ADDENDUM NO. 1

WASHINGTON STATE PARKS AND RECREATION COMMISSION KOPACHUCK STATE PARK DAY USE DEVELOPMENT SW-C1811

DATE: April 16, 2024

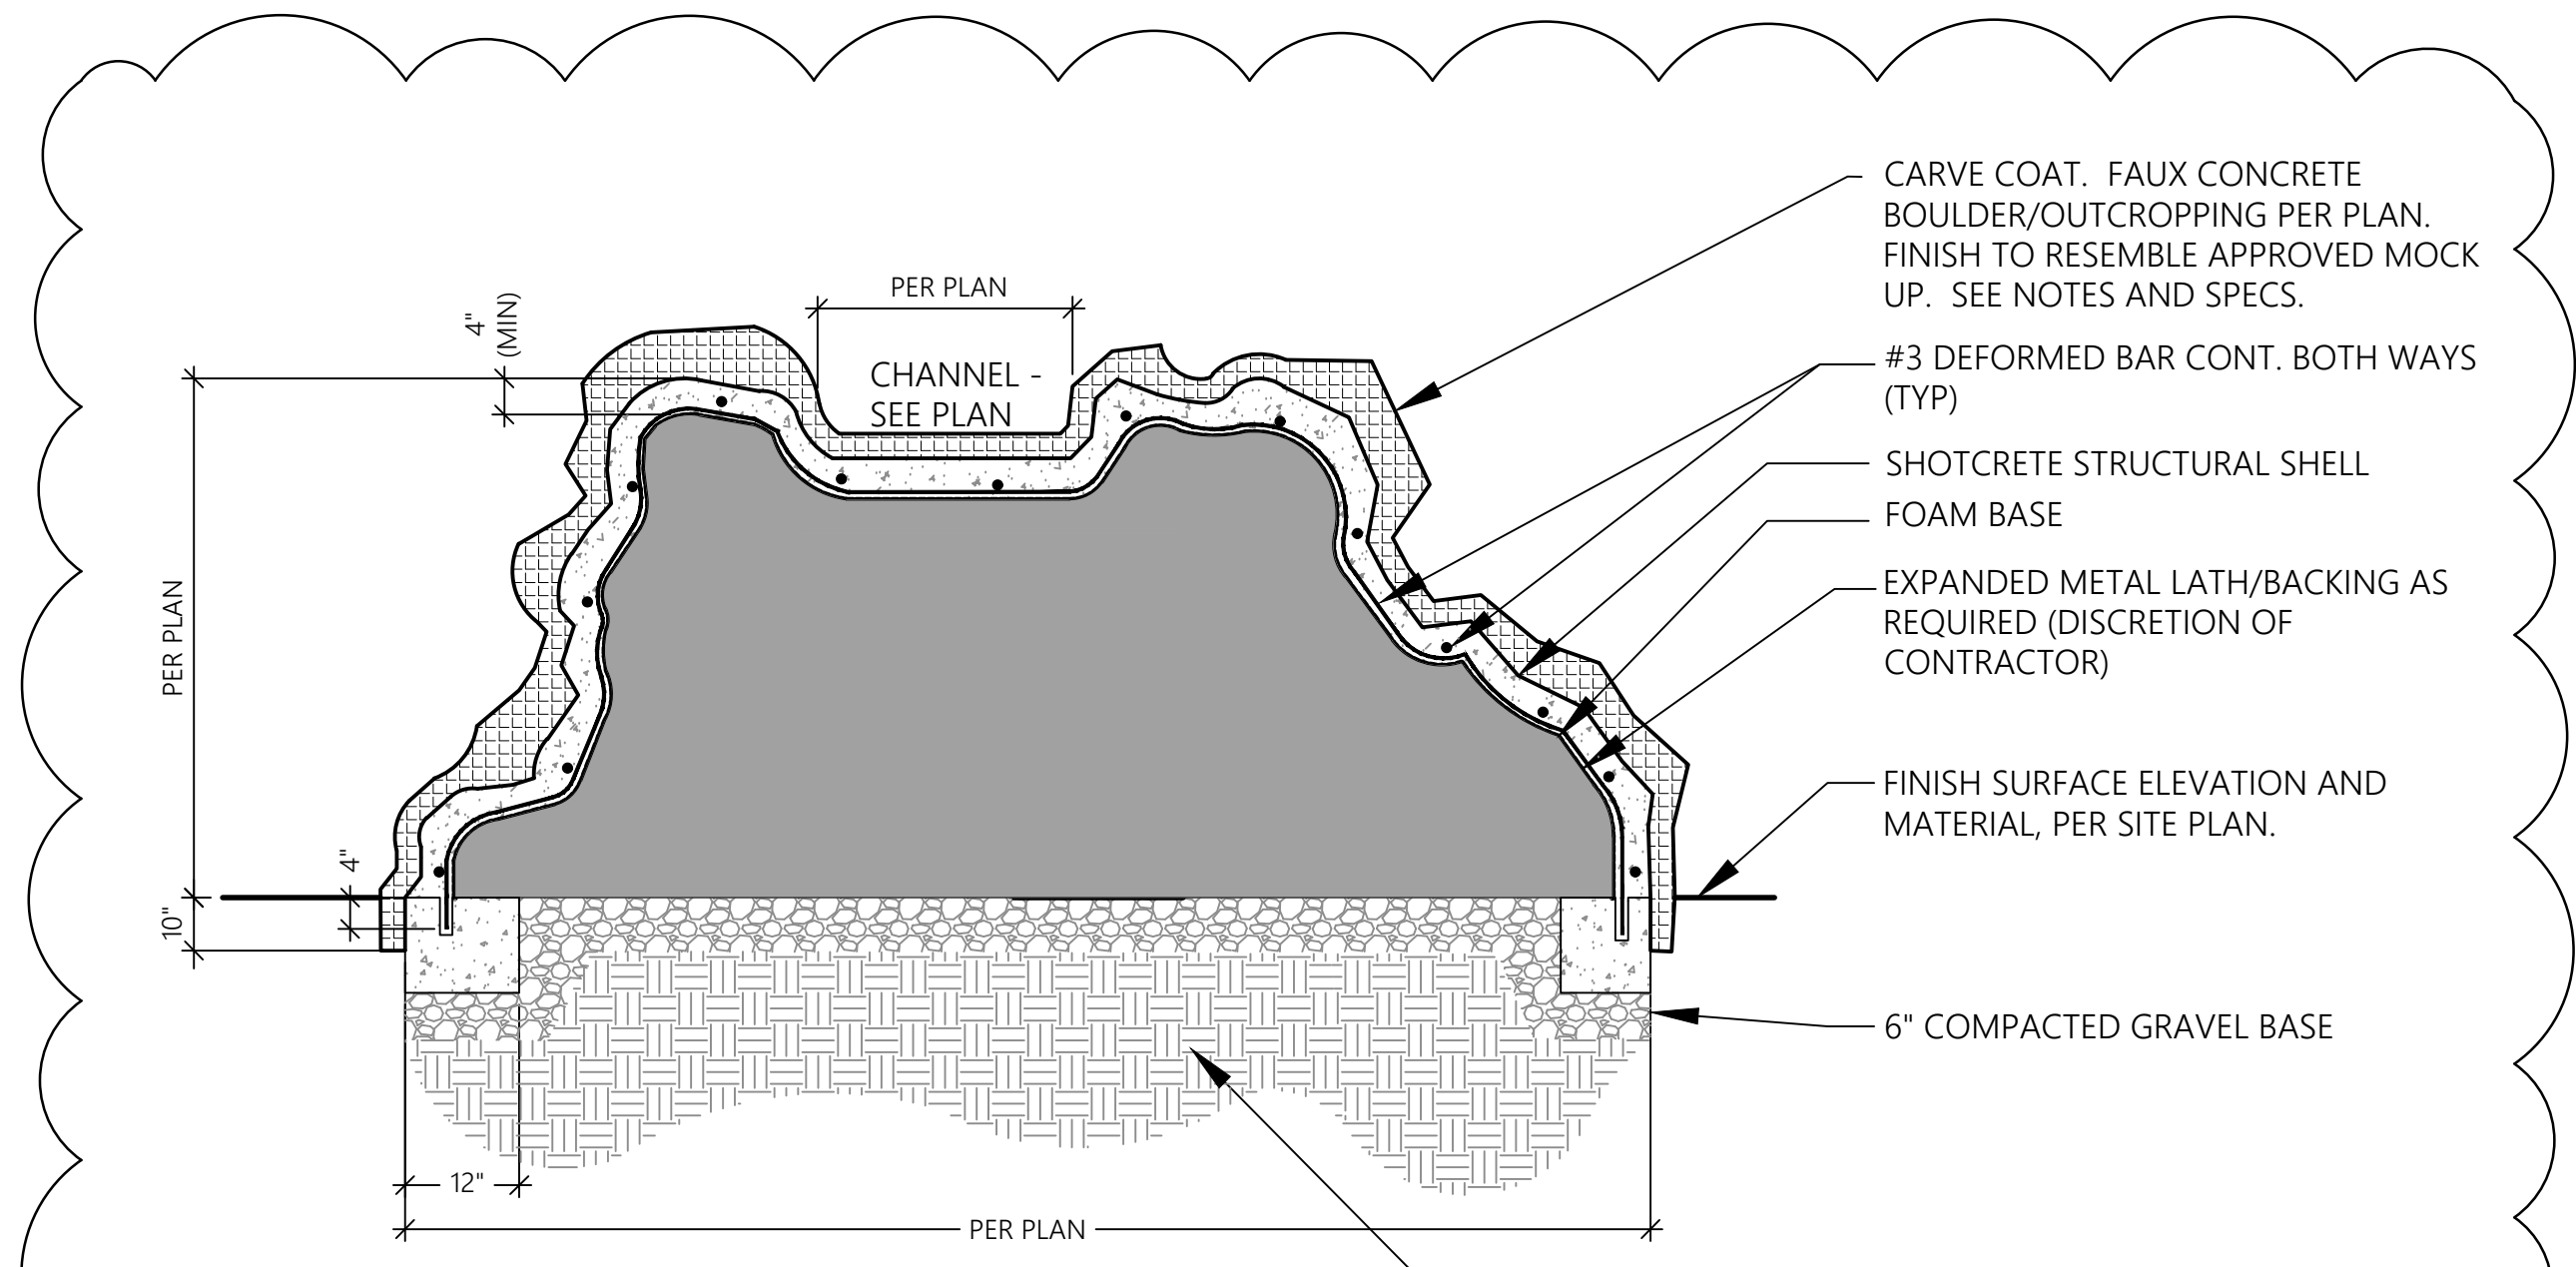
Sheet C5.22: **Revise:** Detail 223 – Typical Feature Section as shown clouded on Addendum Sketch ADD-1.04 attached.
